1R Improvements to Elmwood Avenue (C-3)

Elmwood Avenue from Cadillac Drive to Trinity Square and Broad Street from Trinity Square to Service Road No. 7

NOTICE TO PROSPECTIVE BIDDERS

ADDENDUM NO. 4 Prospective bidders and all concerned are hereby notified of the following changes in the Plans, Specifications, Proposal and Distribution of Quantities for this Contract. These changes shall be incorporated in the Plans, Specifications, Proposal and Distribution of Quantities, and shall become an integral part of the Contract Documents.

CURB EXTENSIONS INSTALLATION DETAIL
NOT TO SCALE

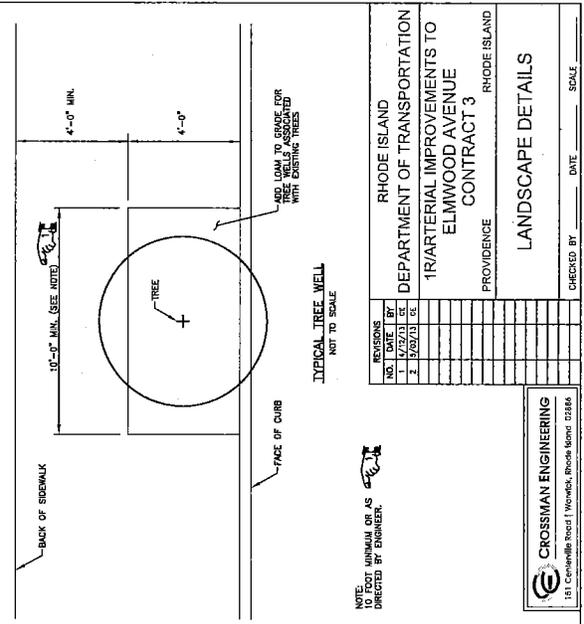
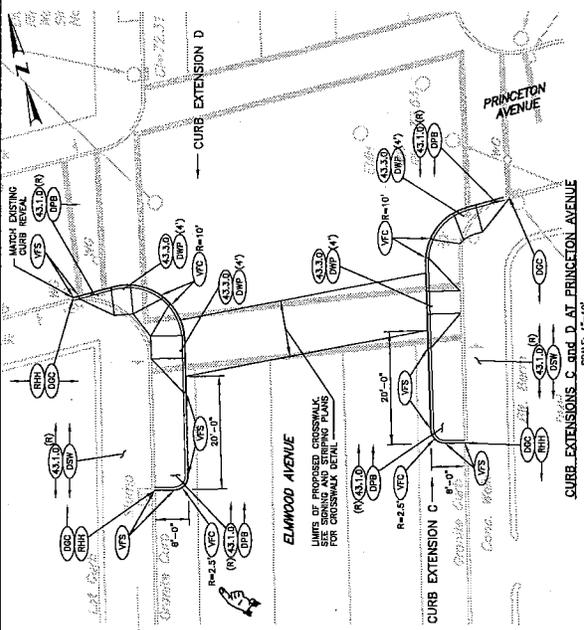
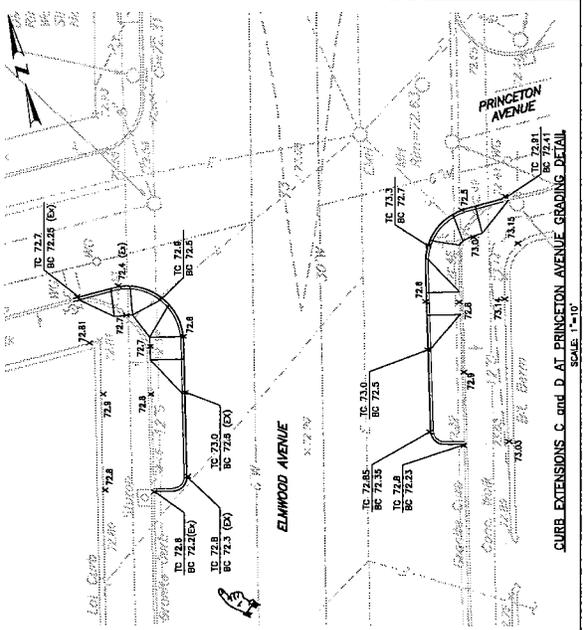
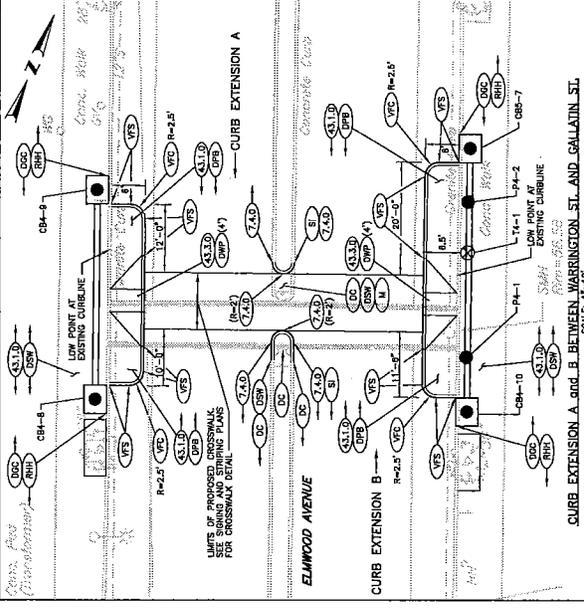
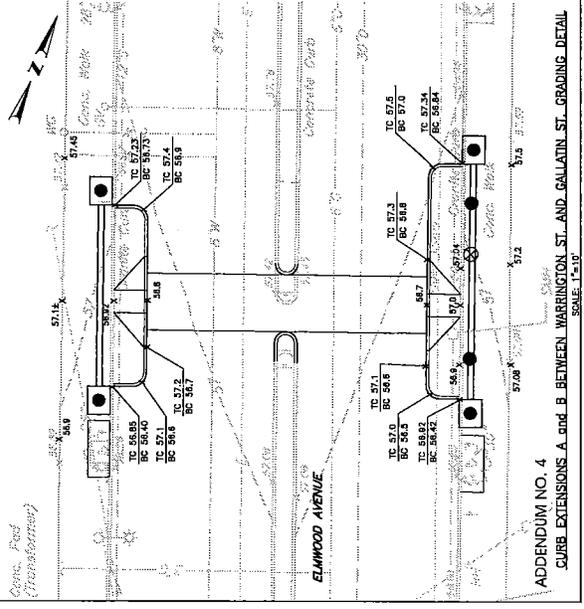
3. Sheet 123 (R-1) – Landscape Details

Remove Sheet 123 (R-1) in its entirety and replace it with revised Sheet 123 (R-2) attached to this Addendum No. 4. The Curb Extensions Installation Detail has been revised to indicate Class A Portland Cement Concrete for the curb lock.
